Virgil C. Summer Nuclear Station (VCSNS) Units 2&3
Combined License Nos. NPF-93 and NPF-94
Docket Nos. 52-027 & 52-028

Subject: LAR 17-01: VCSNS Units 2&3 Request for License Amendment:
Classification of Nonsafety-Related Instrumentation

**Request for License Amendment:
Classification of Nonsafety-Related Instrumentation**

(LAR 17-01)

Figure 1: Safety Classification of Instrumentation Sensing Line, Manifold, and Instrument

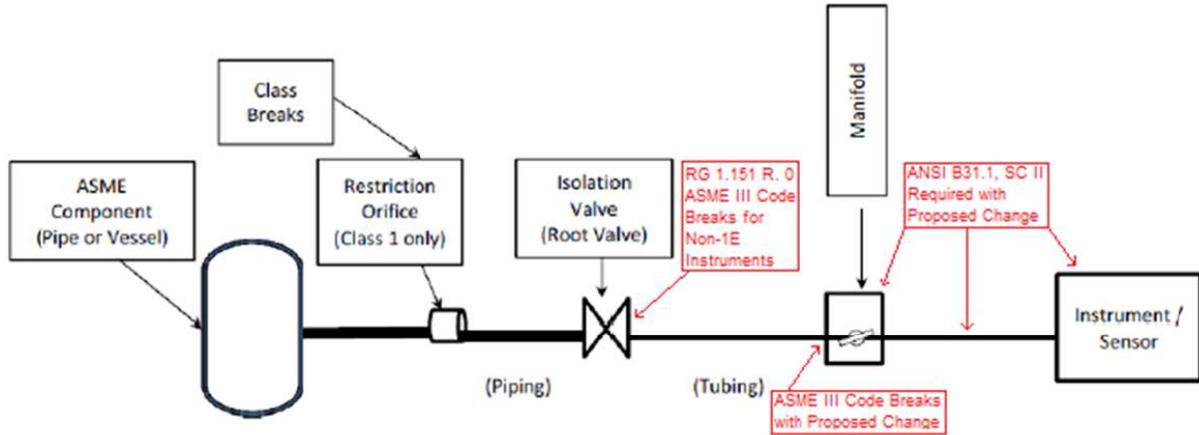
In the absence of specific UFSAR requirements, this amendment request proposes adding a new classification methodology to UFSAR Subsection 3.2.2.8 applicable to the instruments listed in Table 1. Specifically, the proposed activity adds information to UFSAR Subsection 3.2.2.8 to describe that the instrument, manifold, and impulse line of nonsafety-related instruments that monitor safety-related pressure boundaries be classified as equipment Class D, seismic Category II. The instrument sensing line from the system piping to the manifold, including the instrument isolation valve, are proposed to be safety-related, seismic Category I. The equipment class applied to the safety-related portions is proposed to be the same as that of the monitored system, which is the same approach applied to safety-related instruments. The proposed changes are shown in the highlighted portion of Figure 1 below.

Note: Section in red border reflects proposed changes, other sections are consistent with current classification methodology.

Plant-Specific Change	Description of Proposed Change
UFSAR Section 3.2.2.8	Revise to state that for nonsafety-related instruments interfacing with safety-related pressure boundaries, the instrument sensing lines and isolation valves have safety-related pressure boundary function, and the instrument manifold, sensor and impulse line are nonsafety-related and seismic Category II.

Nonsafety-related instrumentation that monitors safety-related fluid systems is Class D, as defined in Subsection 3.2.2.6. The instrument sensing line is safety-related, seismic Category I from the connected fluid system to the instrument manifold. The instrument, manifold, and impulse line (interconnecting tubing between the manifold and instrument) are Class D, seismic Category II, as defined in Subsection 3.2.1.1.2. The Class D quality requirements include a pressure test at 1.5 times design pressure and a requirement for certified material test reports.
